# TECHNICAL REVIEW AND ADVISORY PANEL

## ONSITE SEWAGE TREATMENT AND DISPOSAL SYSTEMS

#### TECHNICAL REVIEW AND ADVISORY PANEL (TRAP) MEETING

# 15-02 ISSUE FOR TECHNICAL REVIEW AND ADVISORY PANEL CONSIDERATION

92  
 93 Figure 1 Standard Layered Nitrogen Reducing System

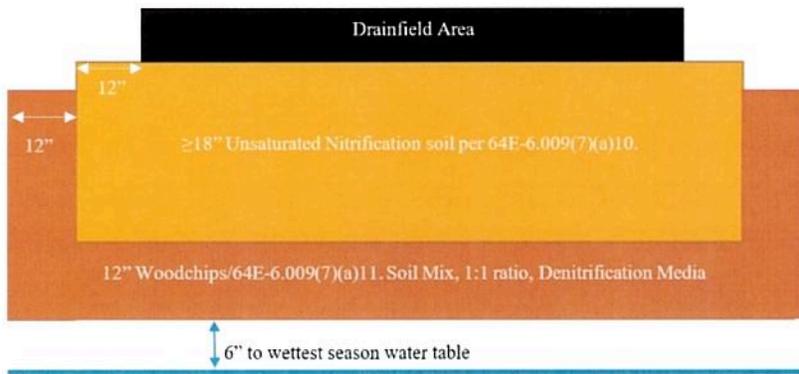
Chairman Odom asked several questions regarding allowing 12-inch separation for repairs; if someone installs a liner that is larger than the 3.5 foot perimeter dimension; a method for mixing the lignocellulosic and sand; the wisdom in not requiring sampling.

Dale Holcomb responded that there is debate whether the 18-inch separation is enough and that 12 inches is probably a poor alternative and will result in less nitrification and therefore less denitrification. Regarding the 3.5 foot perimeter, we are not aware that a five feet perimeter is worse than 3.5 and that the market will probably limit spending on a much larger liner. Methods for the mixing of the media and the sand were discussed. Sampling is not intended to be required to be done at the homeowners expense. An agency that wants to see how well the systems are performing can sample them.

Do not allow 12 inches of separation. 18 inches is probably okay.

Use a 50/50 media/soil mixture

Check the perimeter loading rates. Long narrow drainfields are the goal

17 (a) The Standard Layered Nitrogen Reducing System, Figure 1, shall be installed as follows:

28 5. No portion of the liner or nitrogen-reducing media shall be within 18 inches of the infiltrative surface of the drainfield.

60 14. The perimeter of the liner, in feet, multiplied by the perimeter loading rate shall not be less than the estimated daily  
61 sewage flow for the system. The most restrictive soil texture between the elevation of the bottom of the drainfield and the  
62 elevation six inches below the bottom of the liner throughout the area of the installation and 24 inches beyond the perimeter of  
63 the liner shall be used to determine the nitrogen-reducing media perimeter loading rate.
